THE MARYLAND ZOO IN BALTIMORE

PERIMETER GATE REPORT

SEPTEMBER 2021

#4 BOAT LAKE ENTRANCE

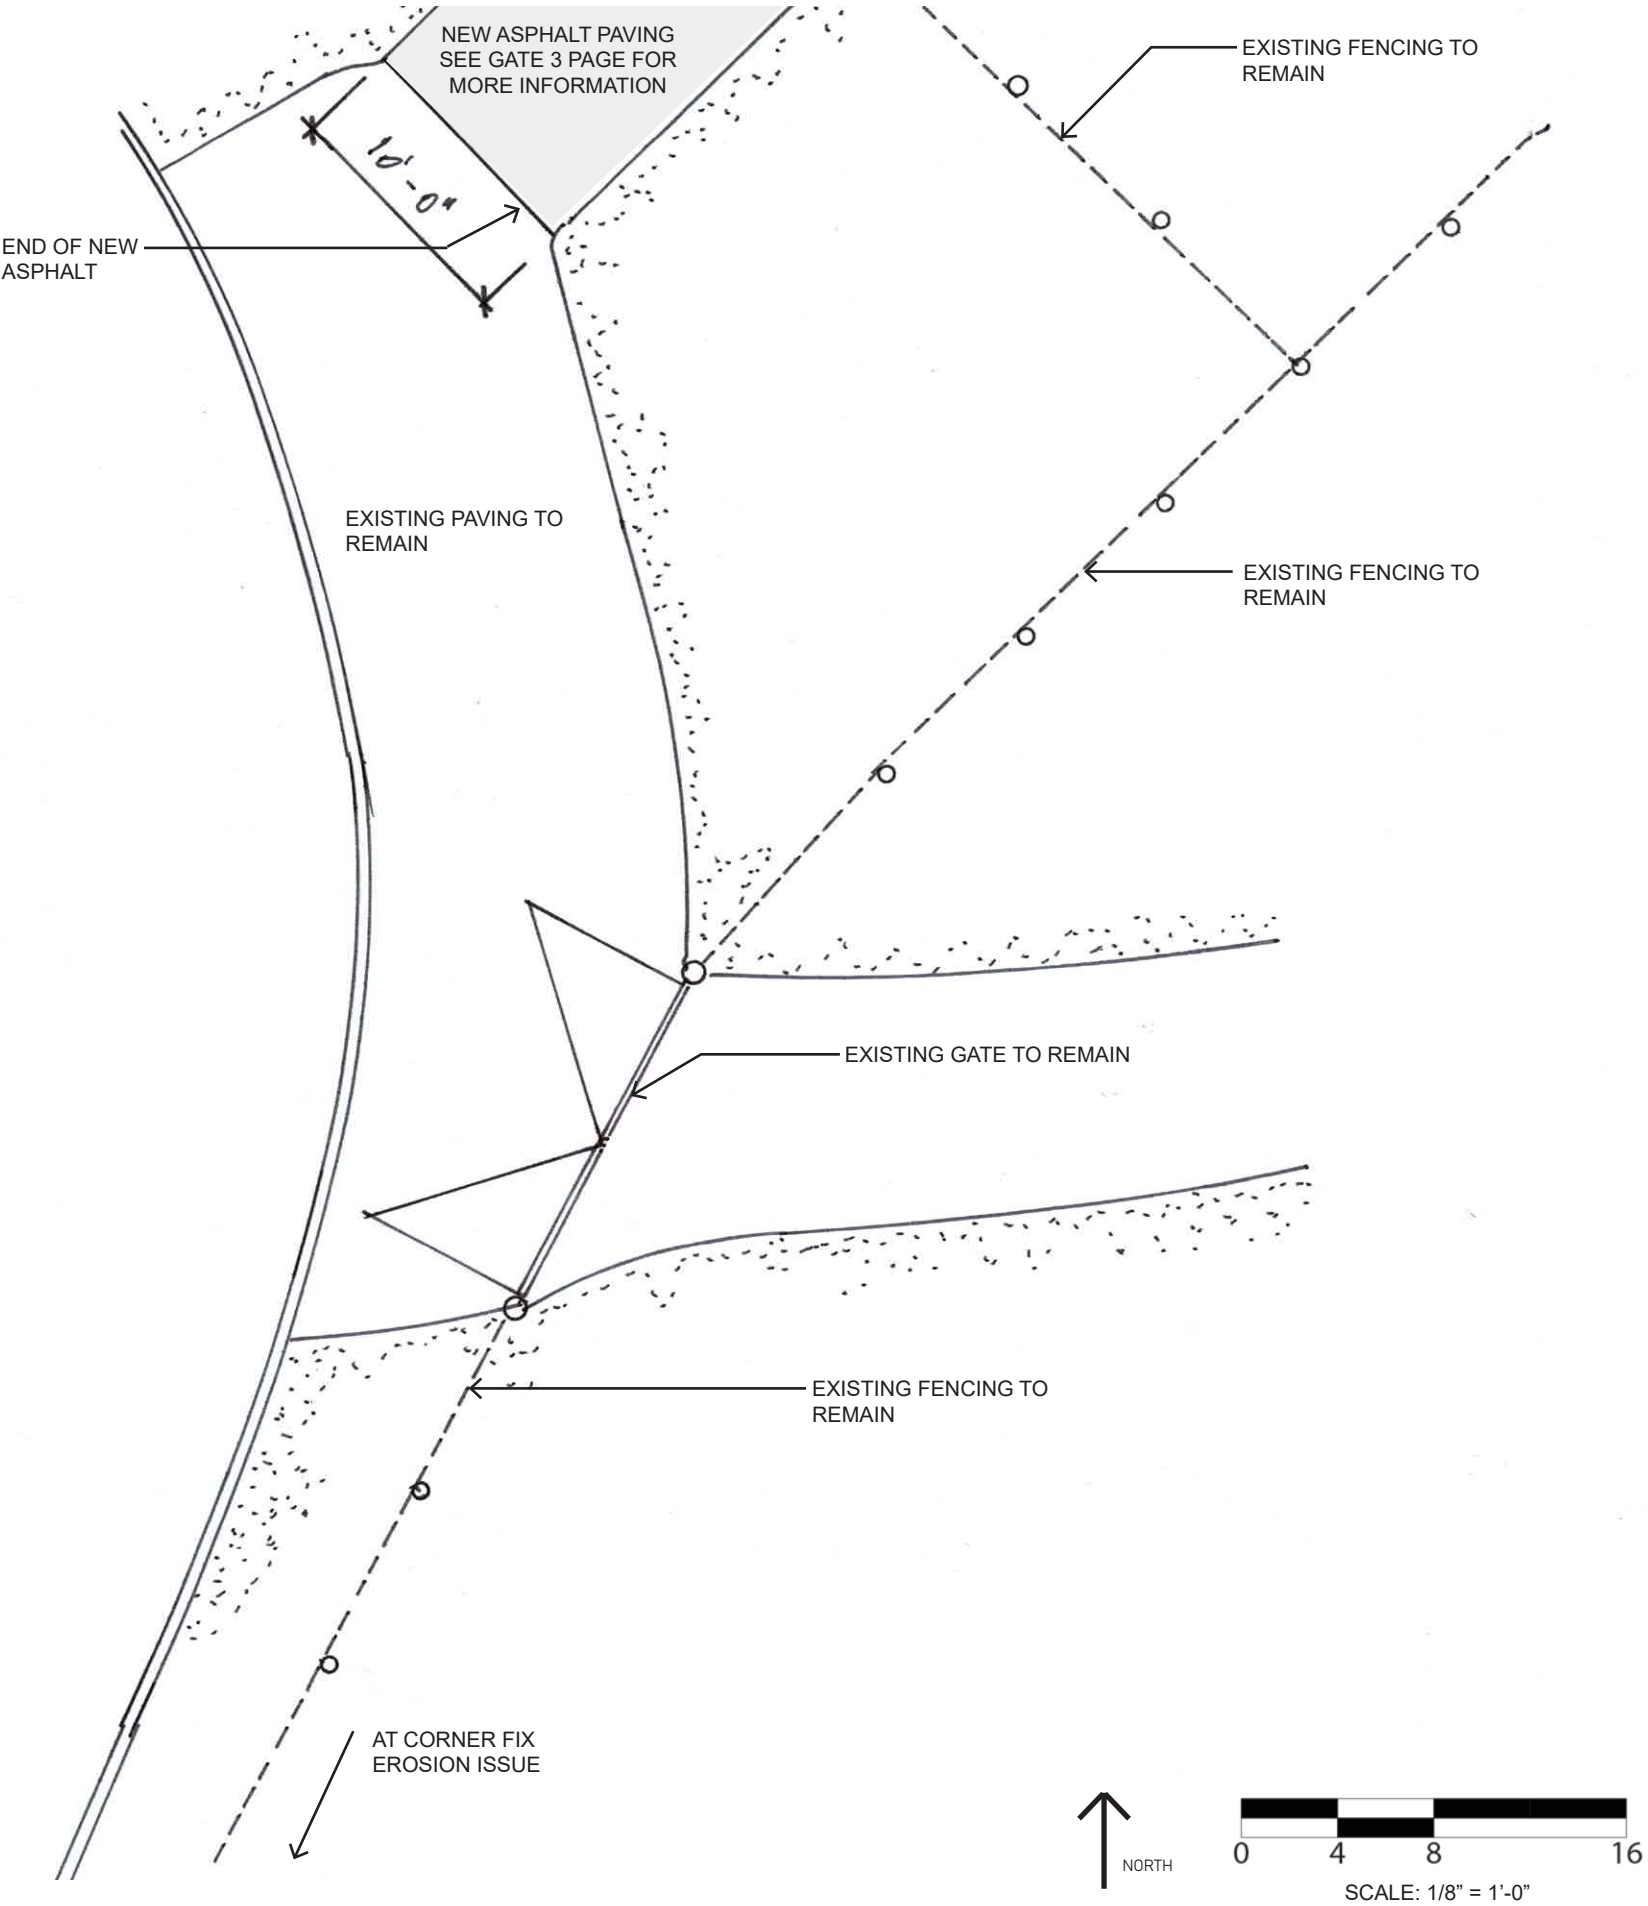
- ~~New sign to match "New Zoo Standard" coordinate text with Zoo.~~

From the curb to two feet past the chain link fence create a 3' wide boulder drainage strip.
Use a mix of round boulders 12" to 14" dia maximum size, down to round boulders 6" to 8" dia.

#6 LAKESIDE GATE

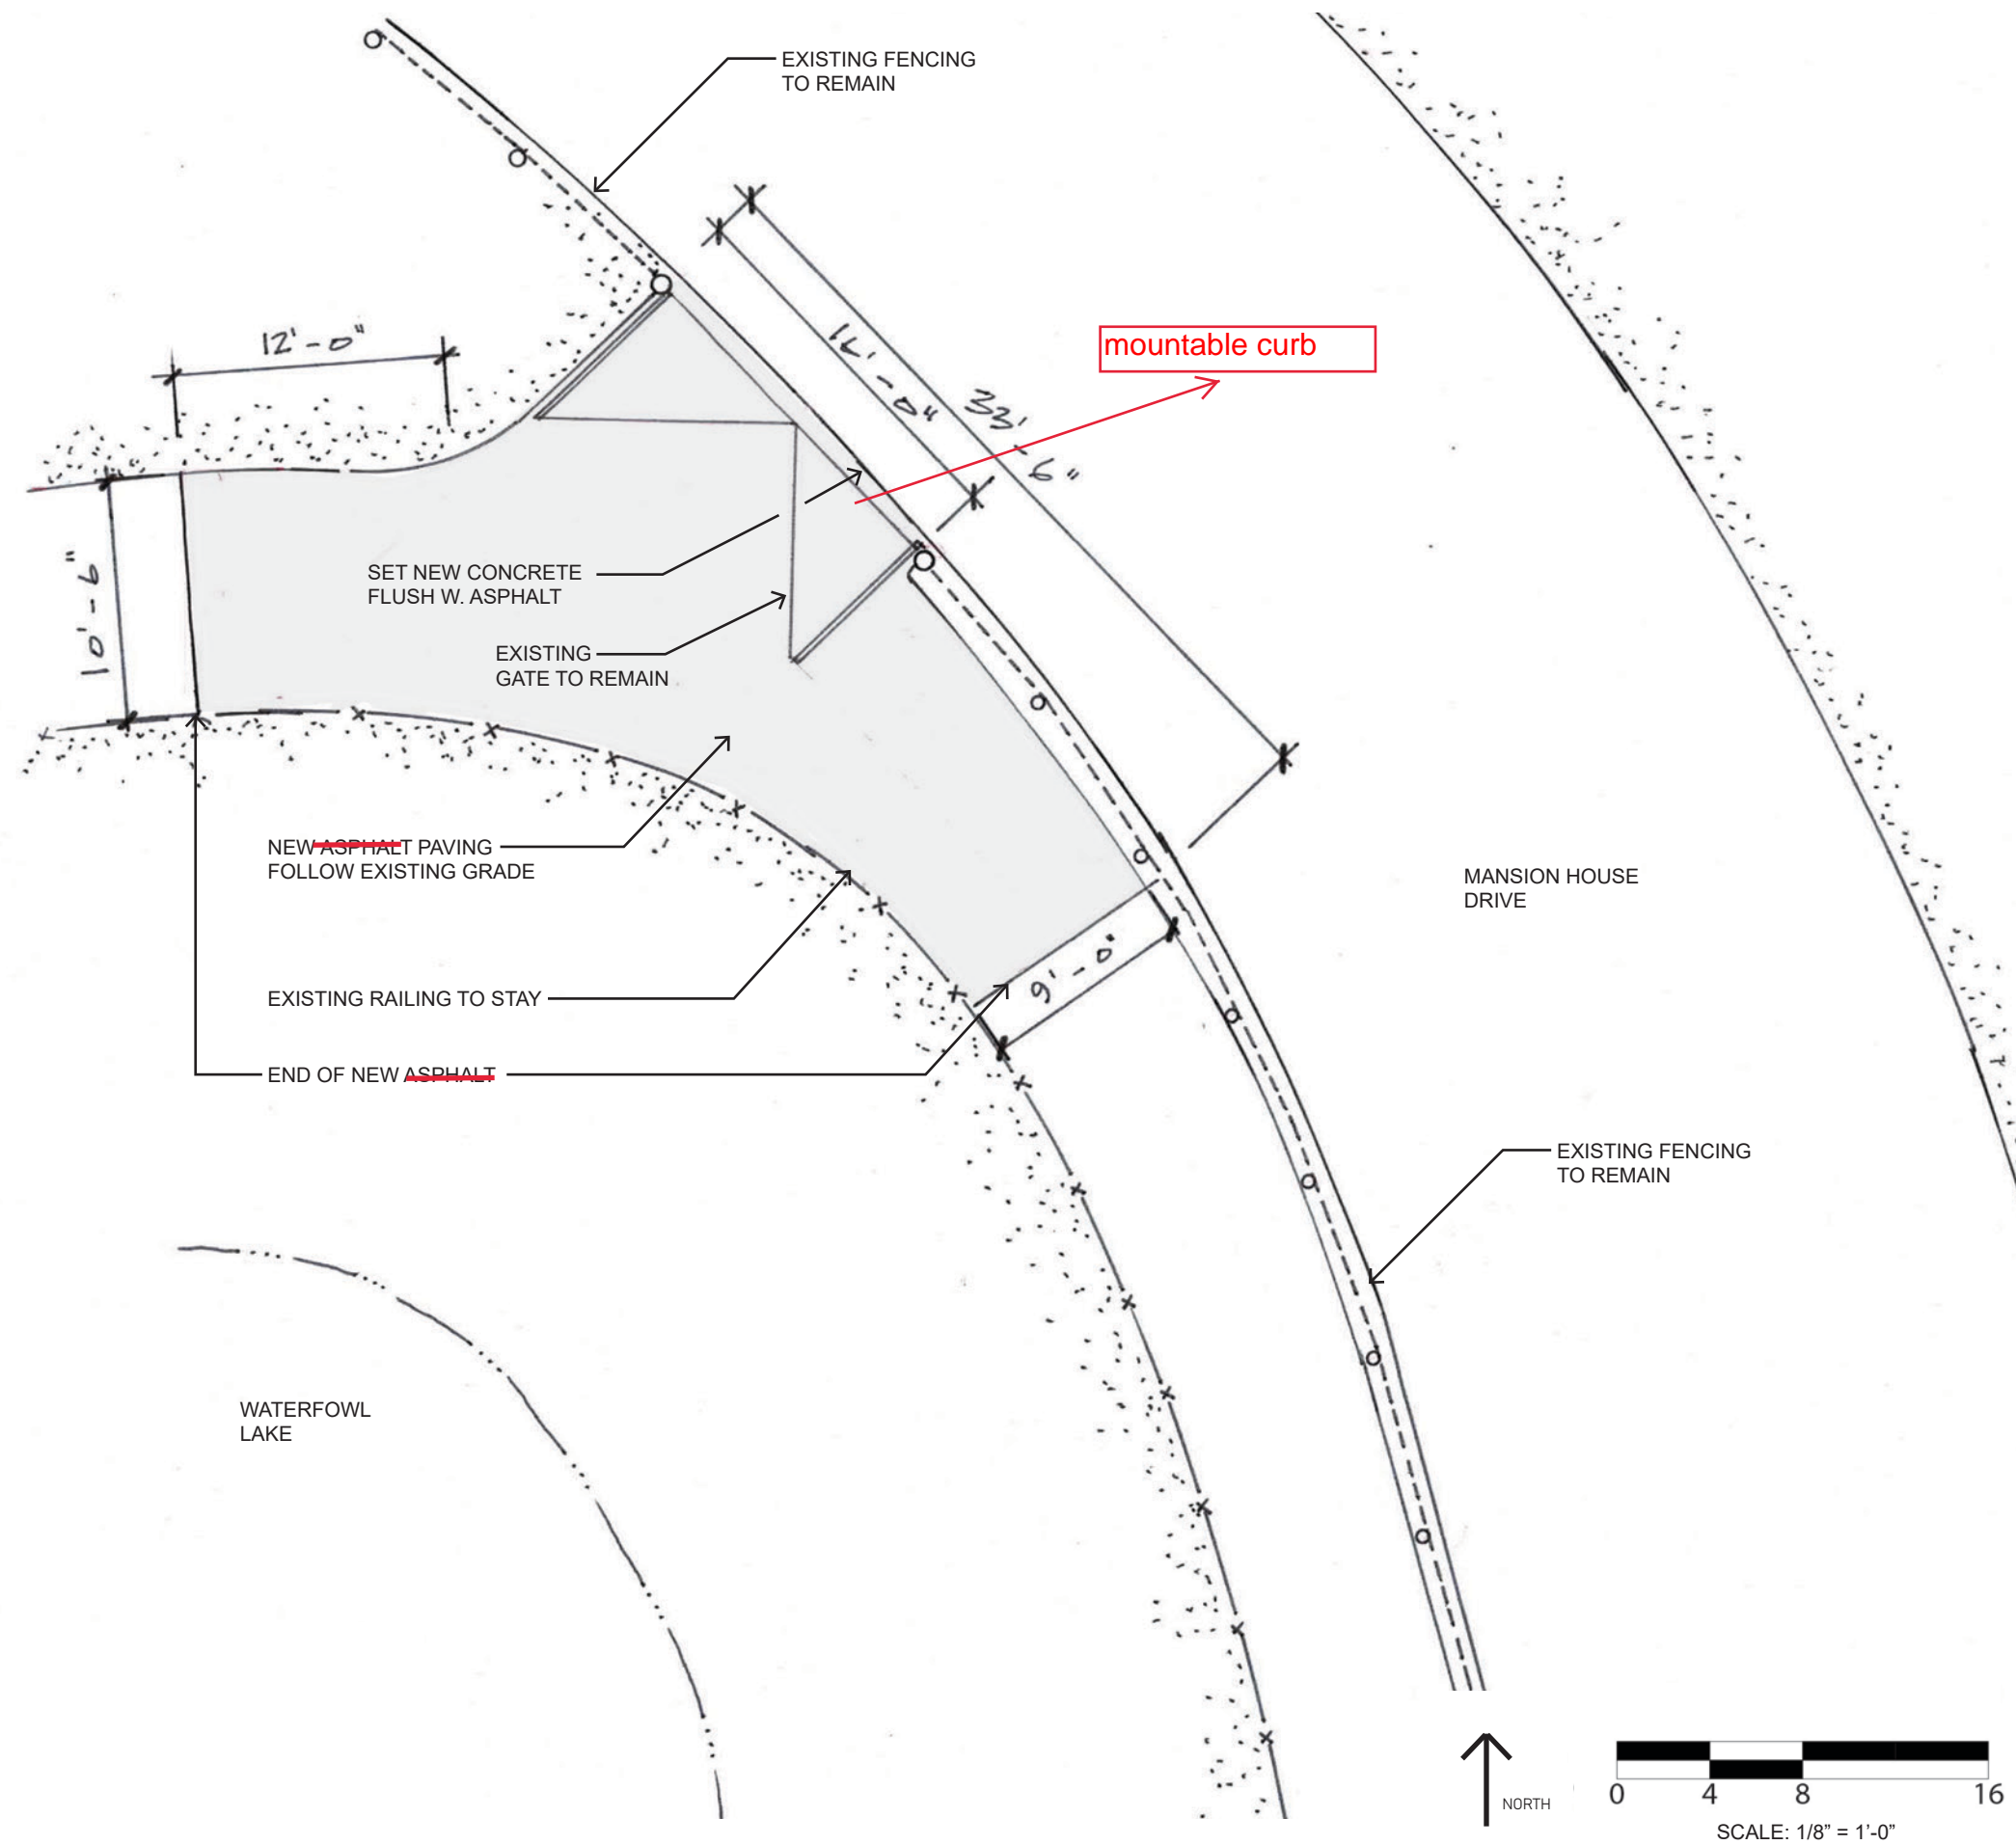
- ~~New sign to match "New Zoo Standard" coordinate text with Zoo.~~
- New ~~asphalt~~ paving. Remove old asphalt and prepare base according to MDOT standards prior to paving.

Concrete not asphalt

#7 WATERFOWL GATE

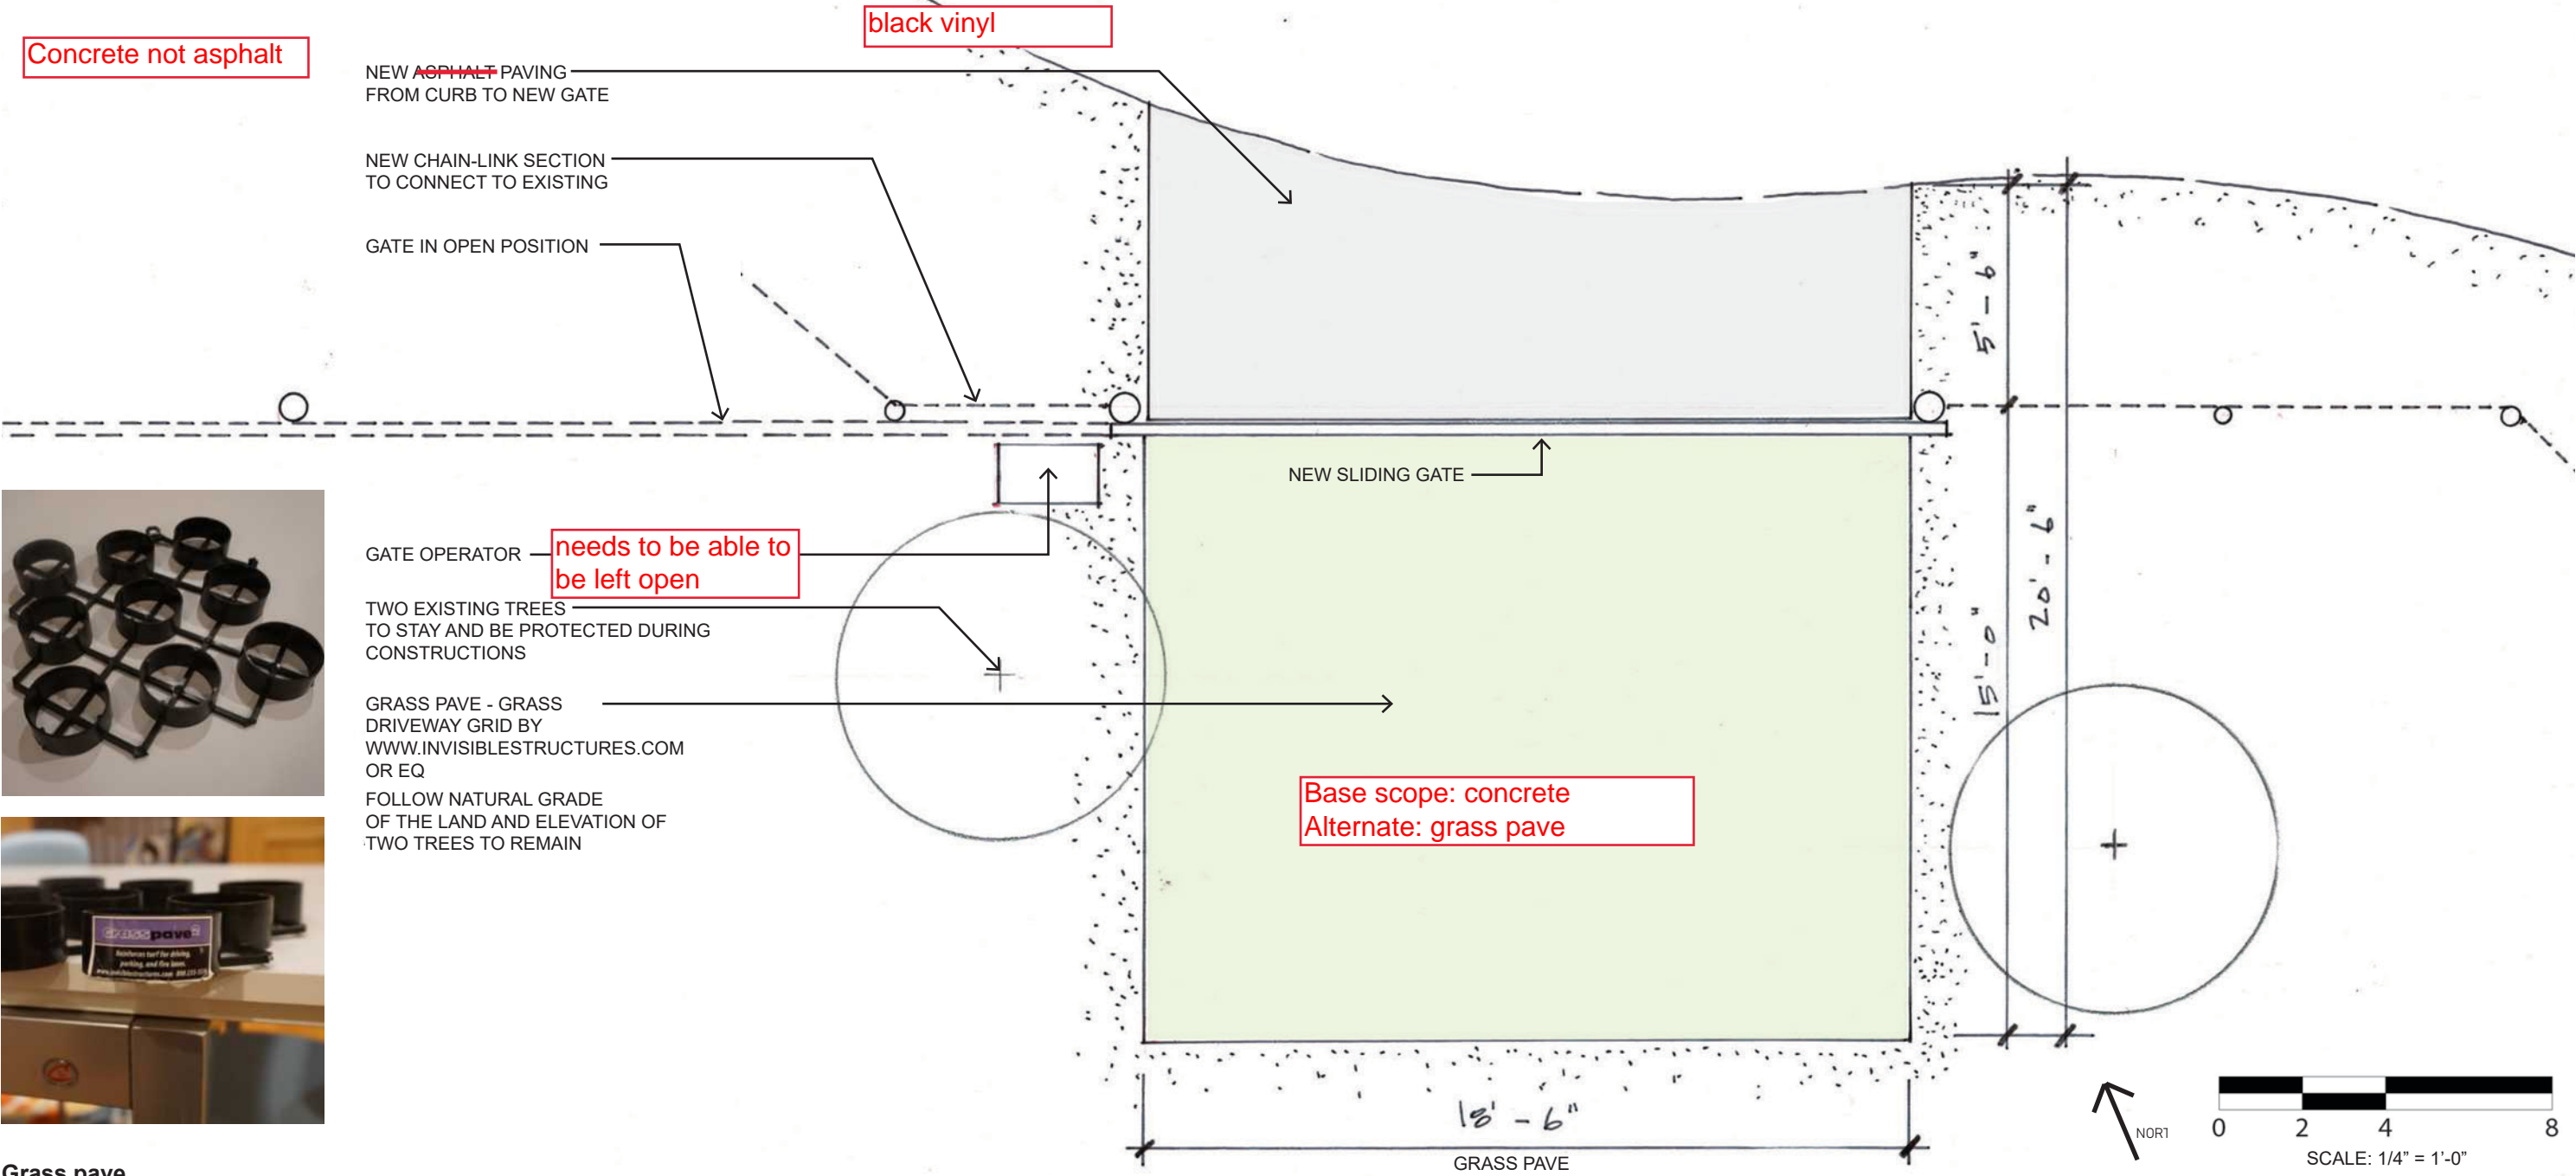
- ~~New sign to match "new zoo standard" coordinate text with zoo.~~
- New ~~asphalt~~ paving. Remove old asphalt and prepare base according to MDOT standards prior to paving.
- ~~For new paving below gate, use grass pave. Prepare according to manufacturer instructions.~~
- Remove old gate and replace with 20'-0" slide gate with electronic operator. Construct according to zoo specifications provided at the end of this report. Add electronic gate operator to the left (interior view).

Grass pave
